Attachment 8 – Shellharbour Local Environmental Plan 2013 Compliance Tables

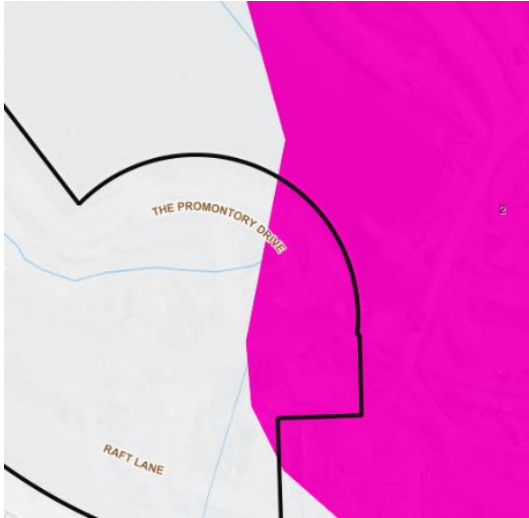
| Part 6 | Local provisions applicable to the development and/or site | How does the development comply (where applicable) |
|-------------------|--|---|
| Clause 6.1 | <p>Acid Sulphate Soils (ASS)</p>  <p>Figure 8.1 - Acid Sulphate Soils location map (marked in pink)</p> | <p>Council mapping systems identify the northern eastern section of the subject site as Class 2 Acid Sulfate Soils indicating ASS just below the soil surface.</p> <p>SMEC Australia Pty Ltd has prepared the Acid Sulfate Soil Management Plan (ASSMP) Precinct B2 & C2 Shell Cove dated 04/05/2018. The report states ASS are most likely to be encountered in the north eastern half of the subject site. Bulk earthworks have been undertaken within the subject site following DA0287/2018, importing 'structural fill' on top of the original ground level. This report was prepared for civil earthworks rather than for any specific development, hence the management actions from this report are general.</p> <p>Further borehole testing has been conducted by SMEC for the Geotechnical Site Investigation – Precinct B2 Shell Cove Boat Harbour Development dated</p> |

| | | <p>11/12/2018. One borehole encountered a layer of estuarine soil that exceeded the adopted threshold of net acidity.</p> <p>This addendum was provided by SMEC dated 20/04/2020 including specific treatments/management measures for ASS exposed and/or excavated for the proposed development.</p> <p>In the report, SMEC gained further information of the extent of the required excavations and extent of ASS already removed by the boat harbour earthworks and concluded that the management actions from section 5 of the Acid Sulfate Soil Management Plan (ASSMP) Precinct B2 & C2 Shell Cove dated 04/05/2018 are sufficient to manage risks for the development, and that dewatering is recommended to be kept at a minimum, however risk of adverse impact of ASS by dewatering is low.</p> |
